RESUBDIVISION OF **GRADY BUICK COMMERCIAL CENTER**

APPLICATION NUMBER 4 DATE August 6, 2009
APPLICANT Grady Buick Commercial Center Subdivision, Resubdivision of
REQUEST Subdivision

GRADY BUICK COMMERCIAL CENTER SUBDIVISION,
RESUBDIVISION OF

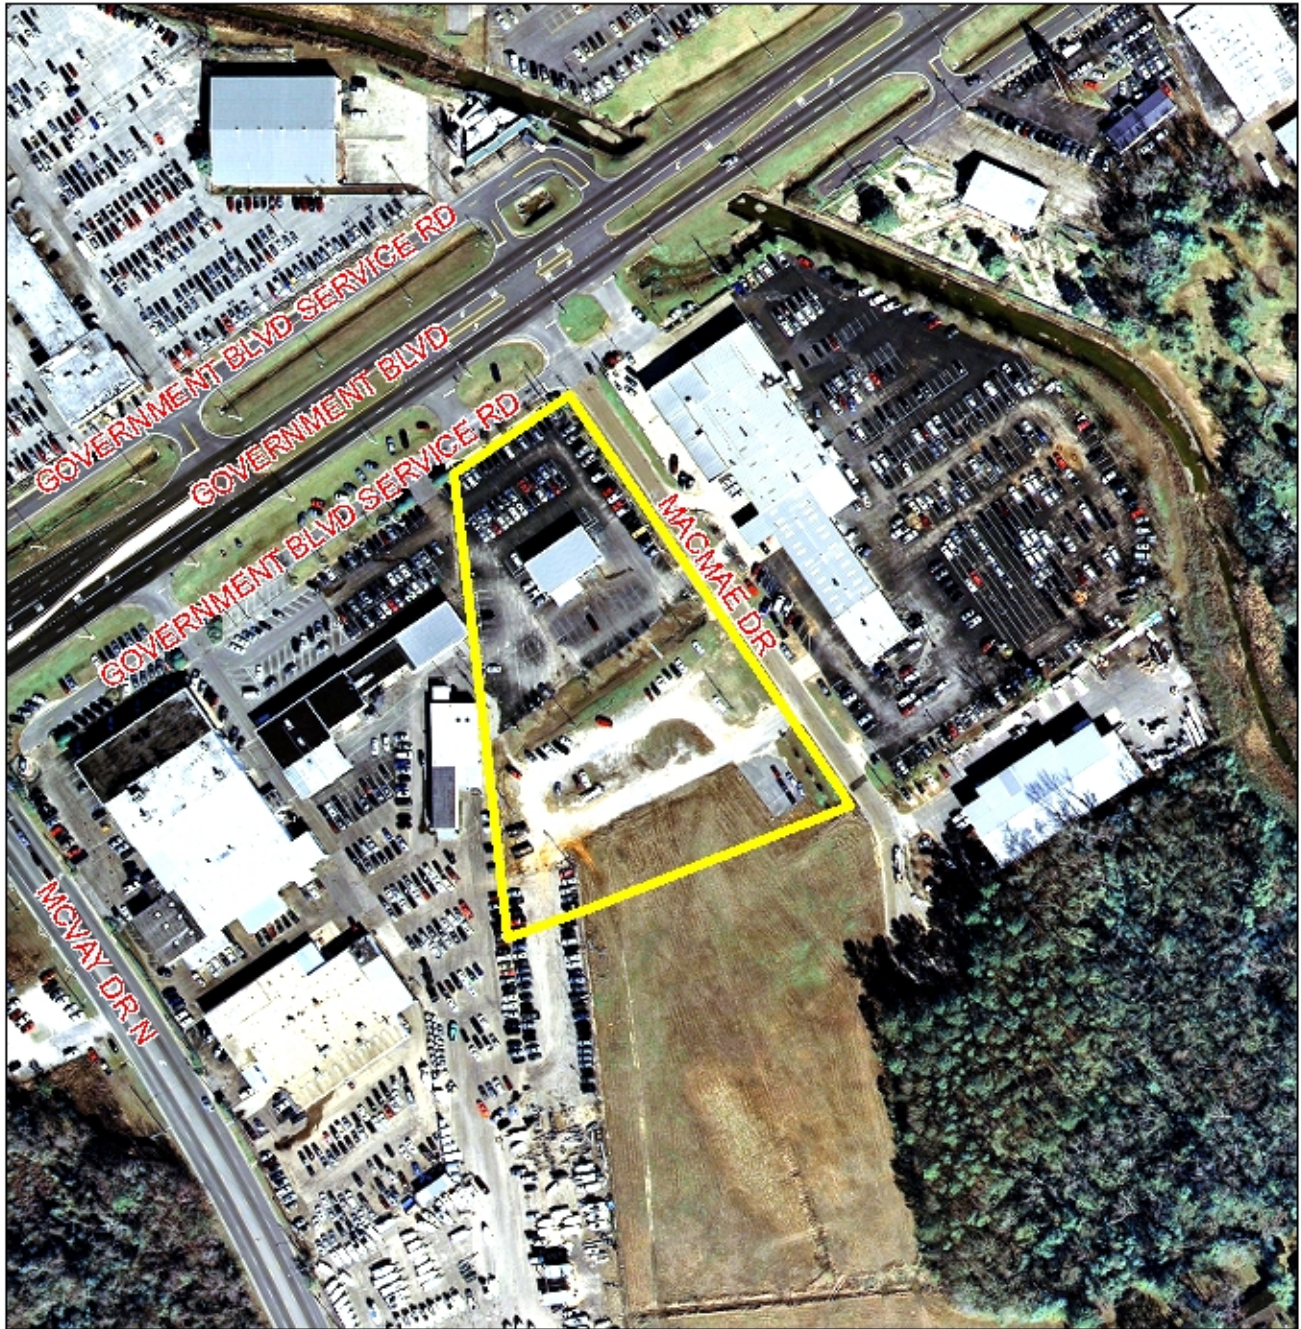
As proposed, the plat does not illustrate an adequate radius where Government Boulevard Service Road intersects Macmae Drive. The applicant should revise the plat to comply with Section V.B.16 of the Subdivision Regulations.

The plat meets the minimum size requirement for developments with access to public water and sewer. However, it is requested that the applicant revise the preliminary plat to label the lots with their sizes in square feet, or provide a table on the plat with the same information.

Lot 1 of Grady Buick Commercial Center is currently developed. Therefore, the applicant should illustrate all existing structures on the final plat to ensure compliance with Section 64-3.E.3 of the Zoning Ordinance.

As illustrated on the plat, the applicant has retained the 20' minimum building setback from Macmae Drive. Section 64-4.D.3 of the Zoning Ordinance allows corner building sites to have a side street setback of 20'. Thus, since the existing development fronts Government Boulevard Service Road, a waiver of Section V.D.9 of the Subdivision Regulations may be appropriate.

- 3) provision of an adequate radius at the corner of Government Boulevard Service Road and Macmae Drive;
- 4) labeling of the lots with their sizes in square feet, or the provision of a table on the final plat with the same information;

- 5) depiction of all existing structures on the final plat to verify compliance with Section 64-3.E.3 of the Zoning Ordinance;
- 6) the applicant receive the approval of all applicable federal, state and local environmental agencies would be required prior to the issuance of any permits or land disturbance activities; and
